PCI-SIG ENGINEERING CHANGE NOTICE

TITLE:	Alternative Routing-ID Interpretation (ARI)
DATE:	August 7, 2006; last updated June 4, 2007
AFFECTED DOCUMENTS:	PCI Express Base Specification version 2.0; PCI Express Base Specification version 1.1 & related 1.1 ECNs
SPONSOR:	Hewlett-Packard

Figure 2-7: ID Routing with 4 DW Header

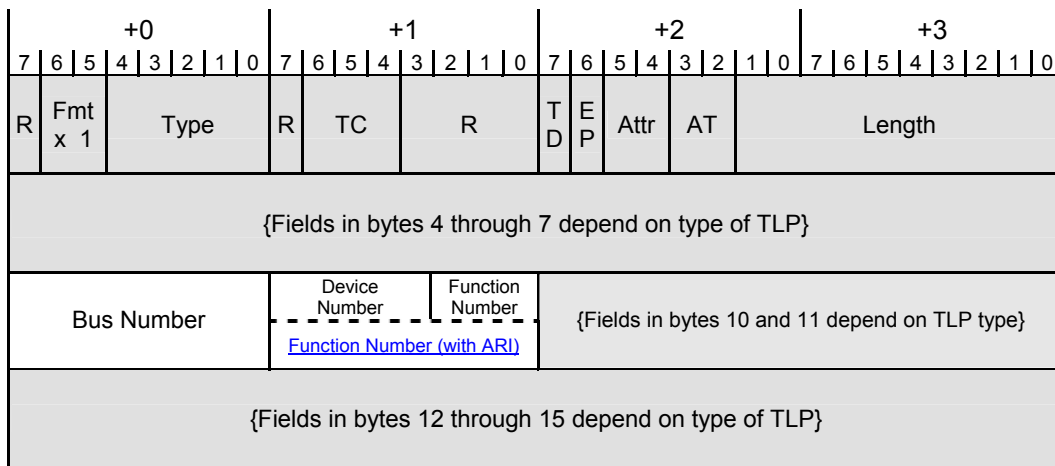
- ❑ ID routing is used with Configuration Requests, optionally with Vendor_Defined Messages (see Section 2.2.8.6), and with Completions
- ❑ ID routing uses the Bus, Device, and Function Numbers ([as applicable](#)) to specify the destination for the TLP:
 - [For non-ARI Routing IDs, the Bus, Device, and \(3-bit\) Function Number to TLP header mapping is shown in Table 2-7.](#)
 - [For ARI Routing IDs, the Bus and \(8-bit\) Function Number to TLP header mapping is shown in Table 2-7a.](#)

- Two ID routing formats are specified, one used with a 4 DW header (see Figure 2-7) and one used with a 3 DW header (see Figure 2-8)
 - Header field locations are the same for both formats, and are given in Table 2-7

Figure 2-20: (Non-ARI) Completer ID

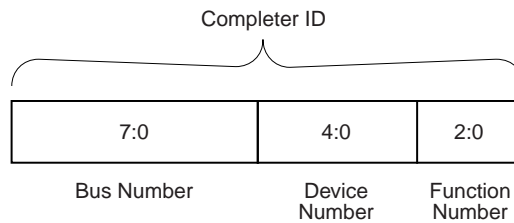
- ❑ The Completer ID[15:0] is a 16-bit value that is unique for every PCI Express Function within a Hierarchy (see Figures 2-20 and 2-20a)

[Figure 6-xx Example System Topology With ARI Devices](#)

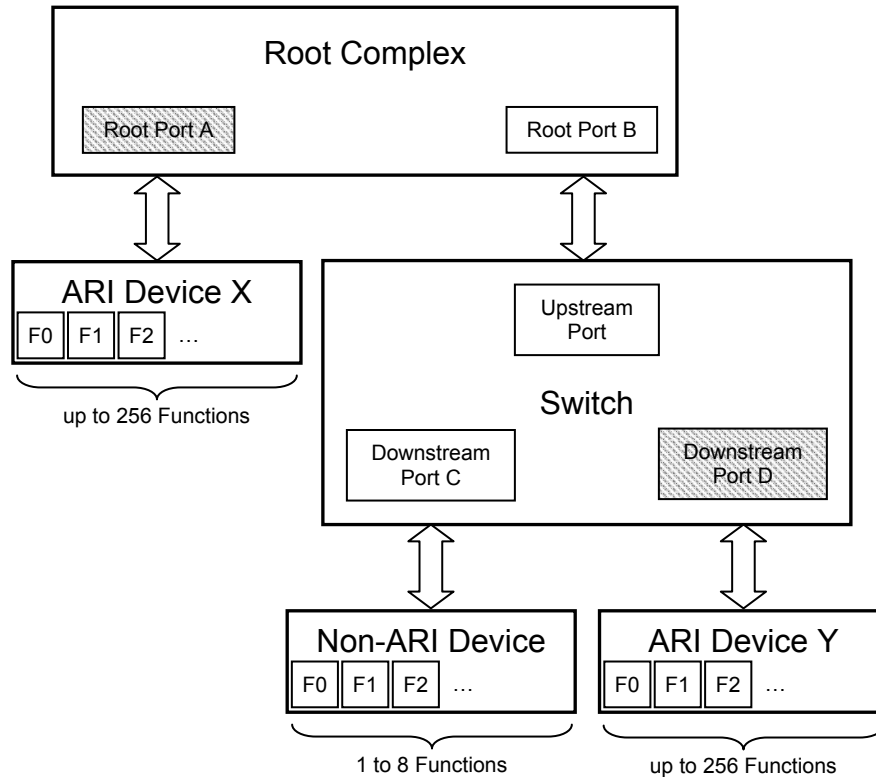
[Figure 6-xx](#) shows an example system topology with 2 ARI Devices, one below a Root Port and one below a Switch. For access to Extended Functions in ARI Device X, Root Port A must support ARI Forwarding and have it enabled by software. For access to Extended Functions in ARI Device Y, Switch Downstream Port D must support ARI Forwarding and have it enabled by software. With this configuration, it is recommended that software not enable ARI Forwarding in Root Port B or Switch Downstream Port C.

Figure 7-24 Device Capabilities 2 Register

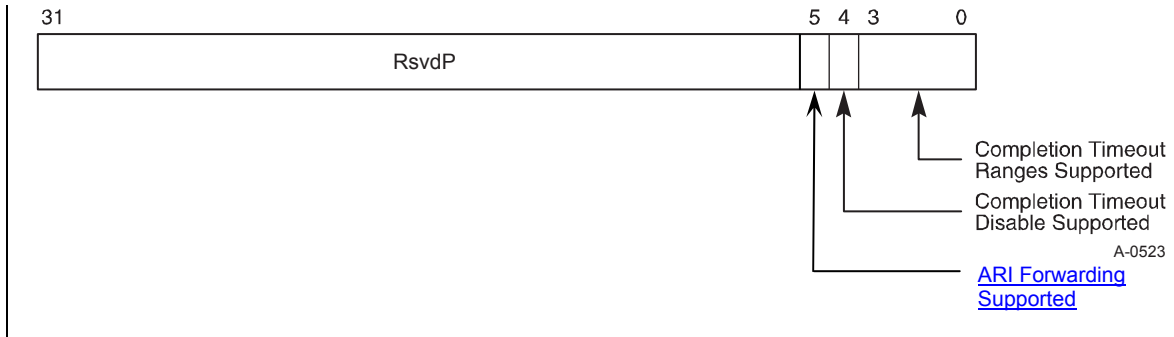
Bit Location	Register Description	Attributes
...
<u>5</u>	<u>ARI Forwarding Supported</u> – Applicable only to Switch Downstream Ports and Root Ports; must be 0b for other Function types. This bit must be set to 1b if a Switch Downstream Port or Root Port supports this optional capability. See Section 6.14. for additional details.	<u>RO</u>

Figure 7-25 Device Control 2 Register

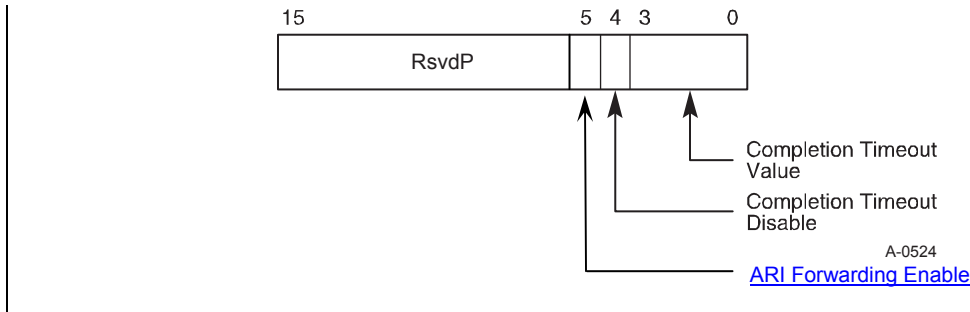
Bit Location	Register Description	Attributes
...
<u>5</u>	<p>ARI Forwarding Enable – When set, the Downstream Port disables its traditional Device Number field being 0 enforcement when turning a Type 1 Configuration Request into a Type 0 Configuration Request, permitting access to Extended Functions in an ARI Device immediately below the Port. See Section 6.14.</p> <p>Default value of this bit is 0b. Must be hardwired to 0b if the ARI Forwarding Supported bit is 0b.</p>	<u>RW</u>
